South Texas Project Electric Generating Station 4000 Avenue F – Suite A Bay City, Texas 77414

February 10, 2010
U7-C-STP-NRC-100036

South Texas Project
Units 3 and 4
Docket Nos. 52-012 and 52-013
Response to Request for Additional Information

Attached are the responses to the NRC staff questions included in Request for Additional Information (RAI) letter numbers 299 and 302 related to Combined License Application (COLA) Part 2, Tier 2, Sections 3.7.1, 3.7.2 and 3.8.4.

Figure 03.07.02-16a1

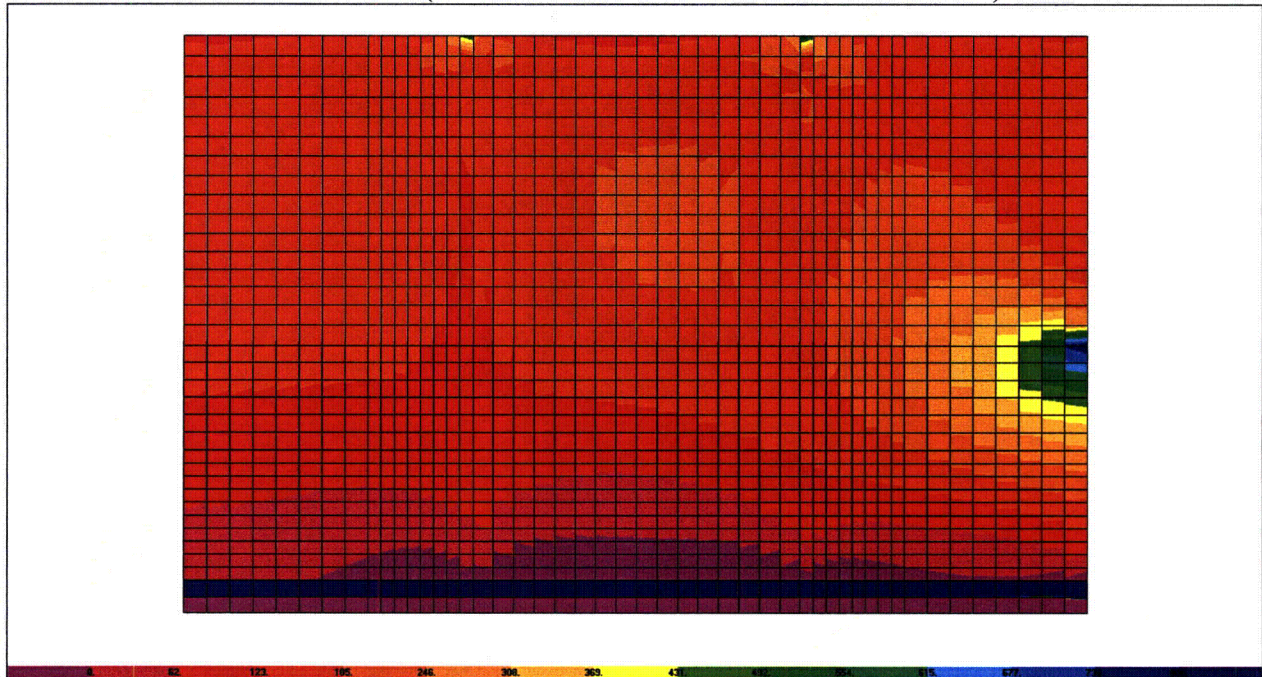
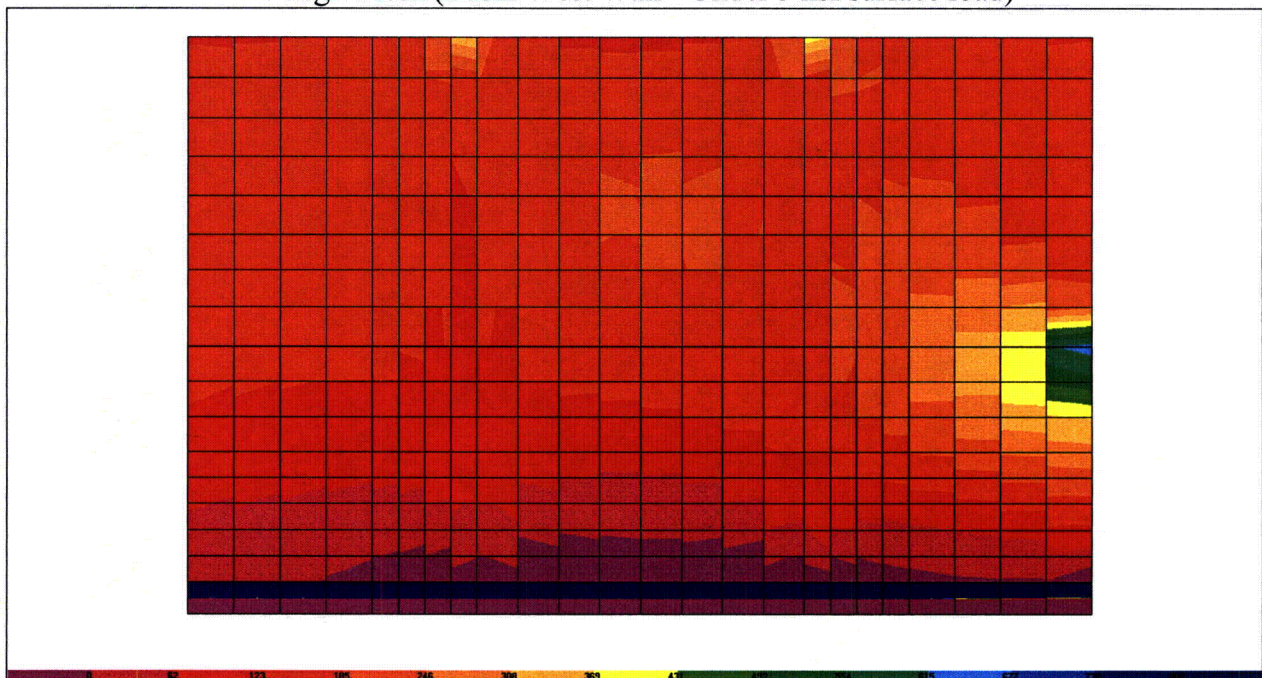
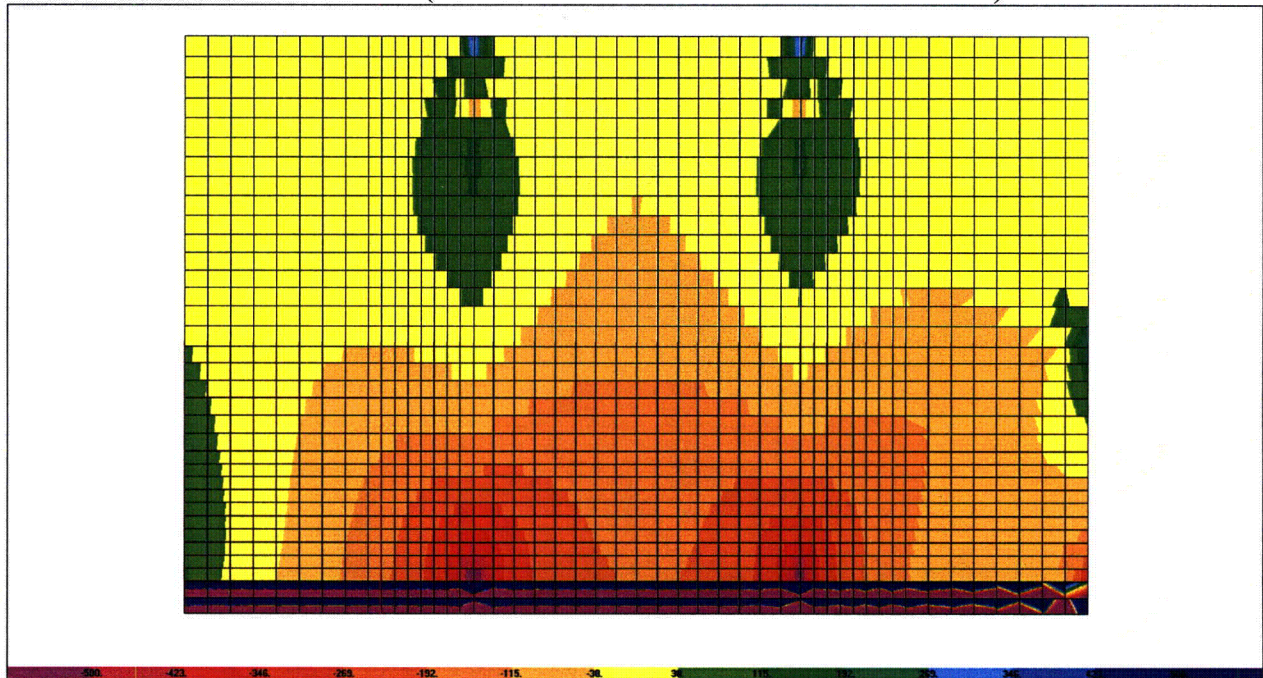
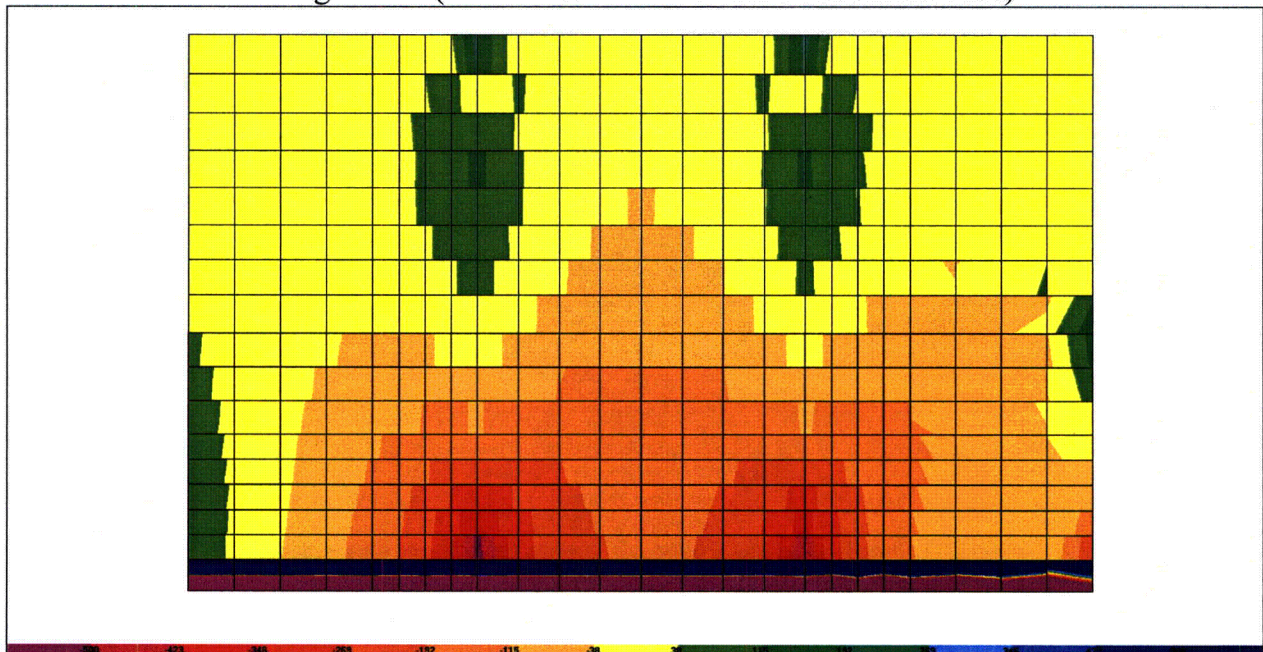
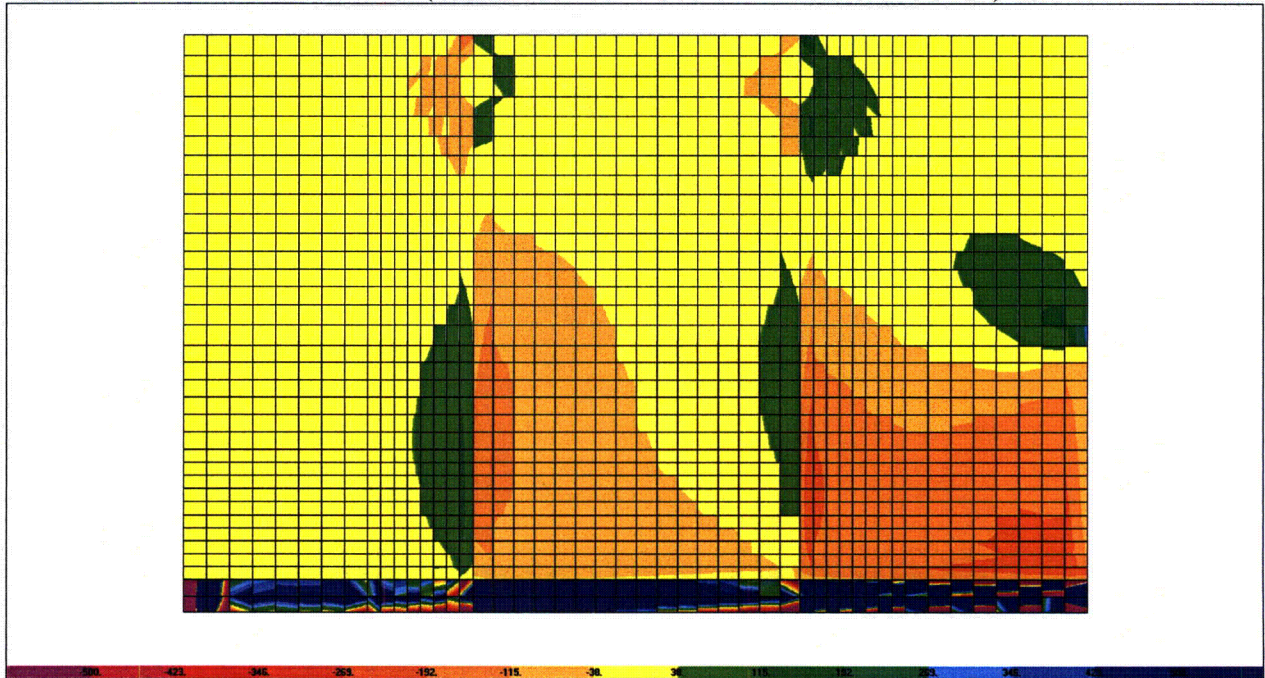
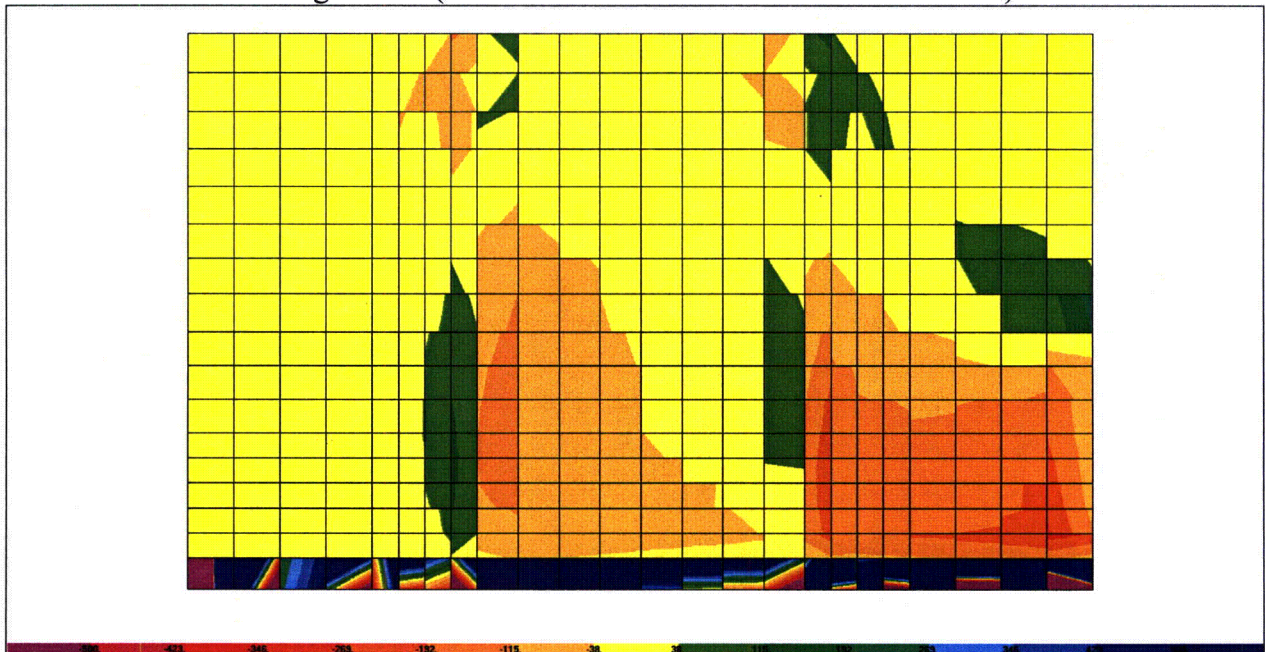
1. In the response to Item 2 of RAI 03.07.01-4, the finite element model of the UHS basin and RSW Pump House was not provided in Figure 3H.6-40 (this figure was supposed to be part of the response to RAI 03.07.01-13). The applicant is requested to ensure this information be part of Figure 3H.6-40, including a plot showing the basement slab and soil-retaining wall mesh configuration and grid sizes. The response to Item 2 of RAI 03.07.01-4 also states that, ***"The model mesh size is detailed enough to model the principal features of the structure and transmit a frequency of at least 33 Hz."*** The applicant is requested to a) provide the criteria and quantitative basis to show that the element sizes are sufficiently small to transmit frequencies of up to 33 Hz for the three soil cases; and b) provide a justification that the aspect ratio of the elements is sufficiently small as not to affect the solution accuracy.

A mesh sensitivity analysis was performed to examine the adequacy of model mesh. This sensitivity analysis was performed by dividing each element into four elements. Sensitivity analysis results are presented for two representative walls. Figures 03.07.02-16a1 through 03.07.02-16a14 show comparison of the resulting membrane and out-of-plane forces and moments for the UHS basin west wall under 5 ksf surface loading. Similarly, Figures 03.07.02-16b1 through 03.07.02-16b14 show comparison of the membrane and out-of-plane forces and moments for the UHS fan enclosure south wall under 2 ksf surface loading. These comparisons show that the results are similar and the mesh used for the design of the UHS/RSW Pump House is acceptable.
